CITY OF ALBUQUERQUE

**RE: Olague Warehouse
1212 3rd St. NE
Grading and Drainage Plan Revision
Engineer's Stamp Date: 03/31/2022
Hydrology File: J14D184**

DRAINAGE AND TRANSPORTATION INFORMATION SHEET (REV 6/2018)

GRADING & DRAINAGE PLAN

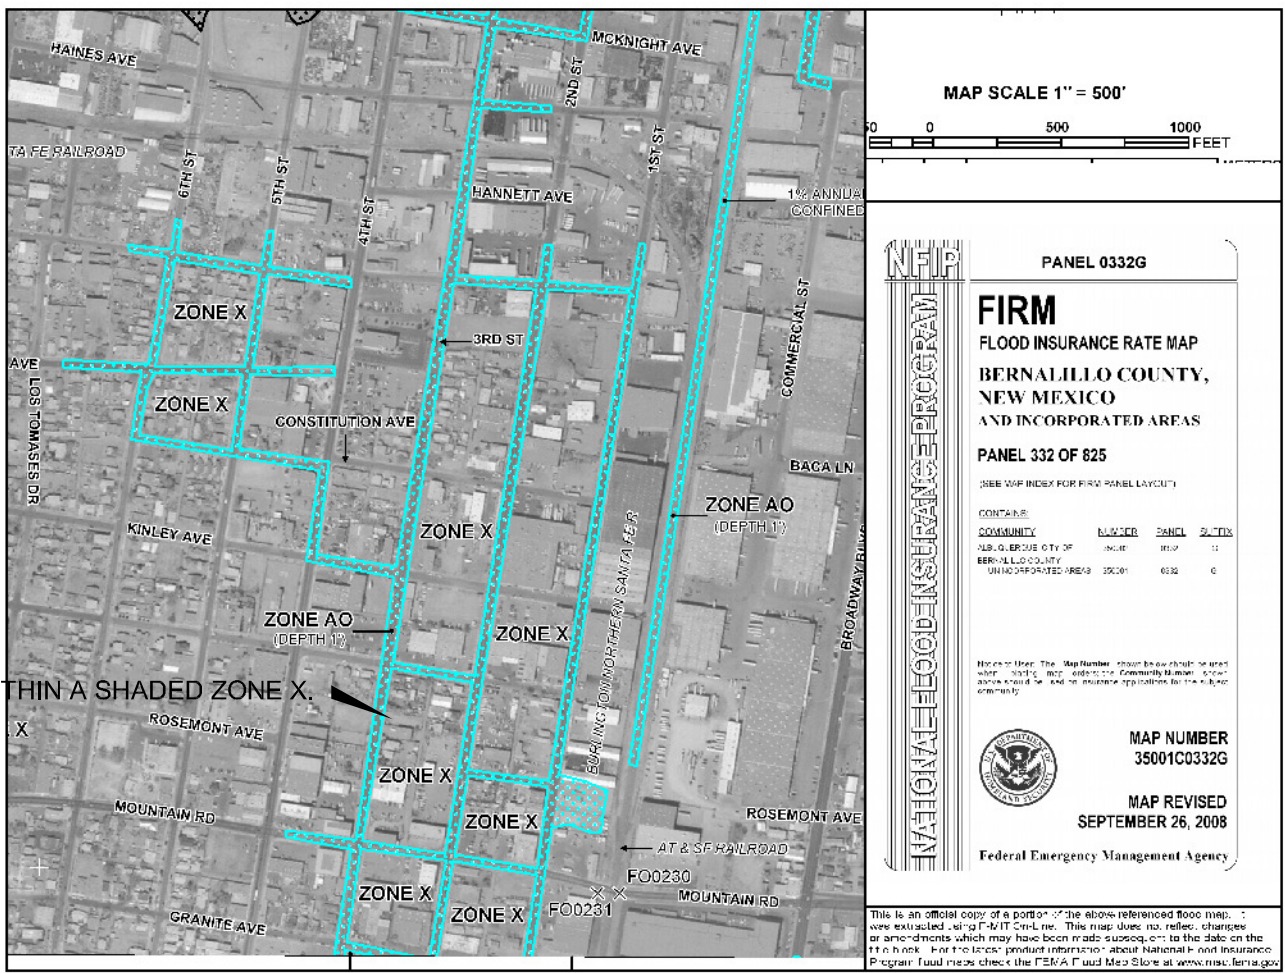
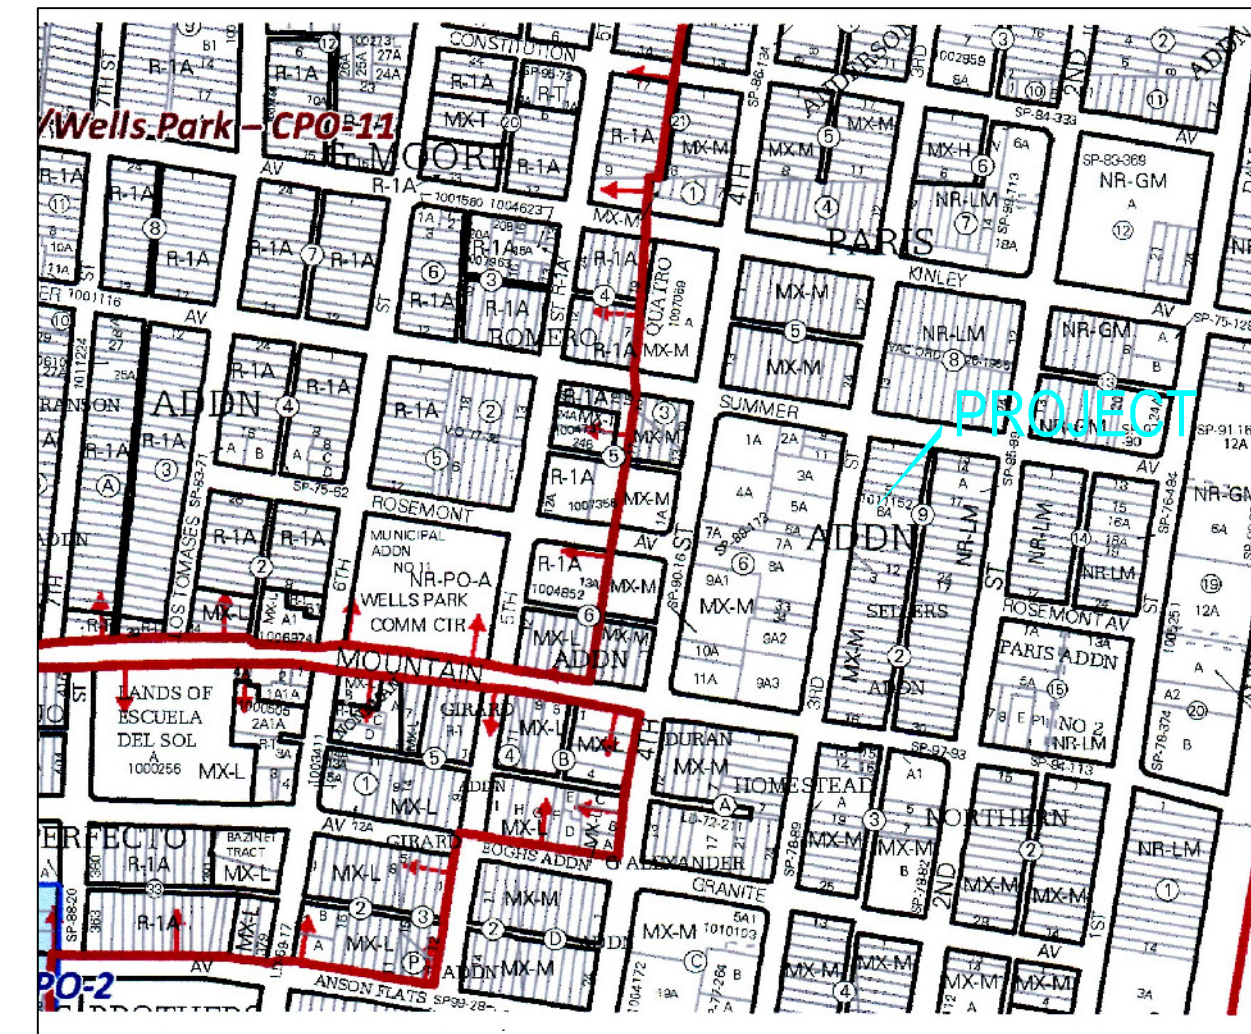
Please provide Drainage Covenant for the stormwater quality ponds per Article 6-15(C) of the DPM prior to Permanent Release of Occupancy. Please submit an electronic file of the Covenant and Exhibit for completeness to Marion G. Velasquez at mgvelasquez@cabq.gov. Once the electronic file is approved for completeness, please submit the original copies along with the \$ **25.00** recording fee check made payable to Bernalillo County to Marion on the 4th floor of Plaza de Sol. Please note that Hydrology will need a pdf copy of the recorded Drainage Covenant prior to Hydrology's approval of Permanent Release of Occupancy.
